Re: 2-6 Hassall Street, Parramatta – Response to Submissions

I refer to the Site at 2-6 Hassall Street, Parramatta and the Submissions received from City of Parramatta Council (Council) and Transport for New South Wales (TfNSW), regarding the State Significant Development 9670 for the Western Sydney University Innovation Hub (Proposal).

Figure 1: Zones and Crosswalks Assessed

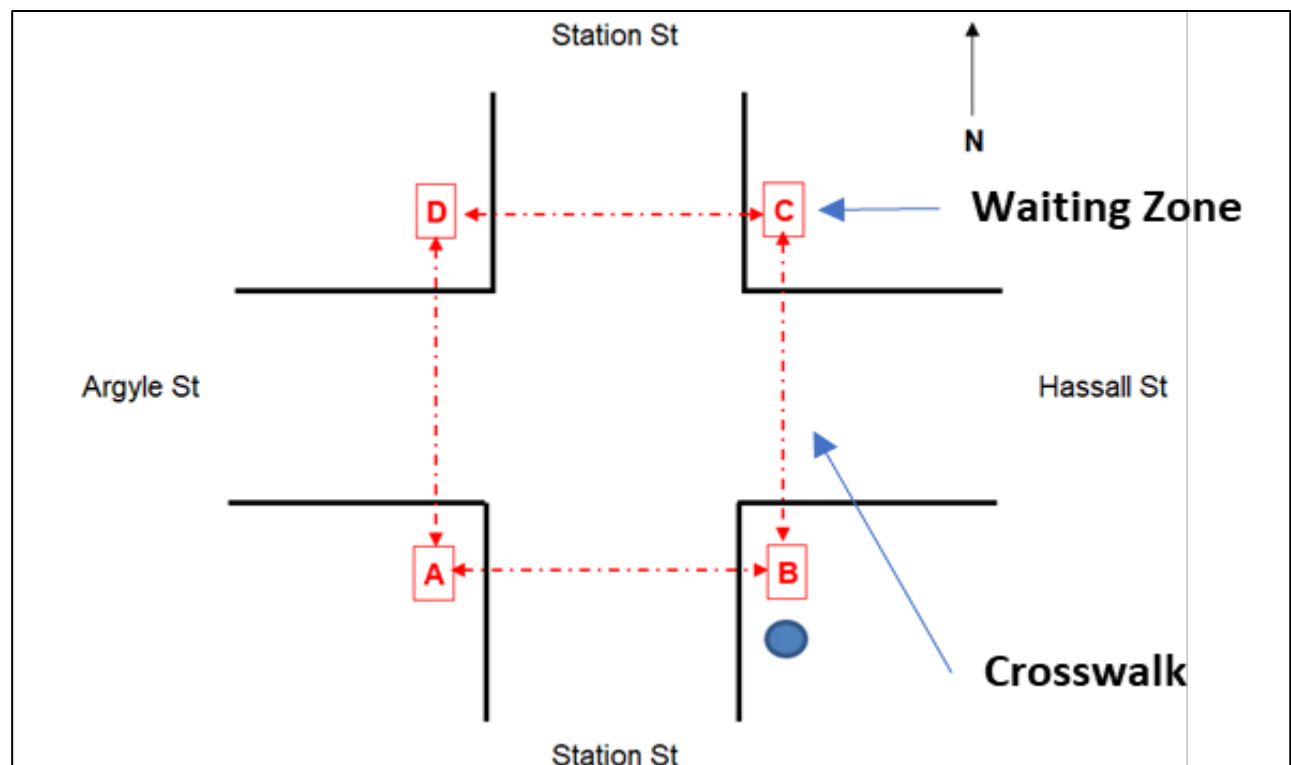
TfNSW requests that the Applicant undertake further assessment of the adequacy of pedestrian facilities including:

- *Fruin analysis of walkways and any pedestrian pinch points along desire lines to public transport nodes.*
- *Measures to improve any constraints or pedestrian safety concerns.*

The analysis should have regard to the potential bunching of pedestrians due to nearby signalised pedestrian crossings and interaction of passengers alighting from public transport and the nearby railway station and interchange.

As noted by TfNSW, the Ason Group transport assessment (reference: *Transport Assessment Report; Western Sydney University Innovation Hub 2-6b Hassall Street, Parramatta*, Issue 1, 12/04/2019 (Ason 2019 Report)), gave particular regard to the signalised intersection of Hassall Street and Station Street East due to it being the key pedestrian desire line and the key concern with regard to pedestrian impacts. The analysis forecast a Level of Service (LoS) C for this location. To further expand on this analysis, **Table 1** summarises the pedestrian results for the Hassall Street & Station Street East intersection, with the corresponding Zones and Crosswalks shown by **Figure 1** for reference.

As is shown by Table 1, the intersection is performing at acceptable levels with densities of LoS C for crosswalks and LoS A for walkways.

The crosswalks are performing at acceptable levels with the worst movements resulting in a Walkway LoS C between B/C and C/D. The LoS C found for Crosswalk C/D is most likely due to the opposing flow of pedestrians heading to the Interchange and to the Site. The performance of Crosswalk C/B is most likely due to the small crossing catering for moderate contra-flows of patronage.

The Waiting Zones all perform at acceptable levels, with LoS A. Unsurprisingly, the highest density of 0.67ped/m² found at Waiting Zone D was due to the high demand for access from the Interchange, to the Site. This greater acceptability for higher densities is due to the Queueing LoS scales facilitating a greater tolerance for a higher volume of pedestrians when they are standing and waiting compared to moving. Additionally, these measurements also consider pedestrians ‘passing-by’ the Waiting Zone of the opposite side. This is likely to occur as this is not a scrambled crossing of movements to C from D and B simultaneously.
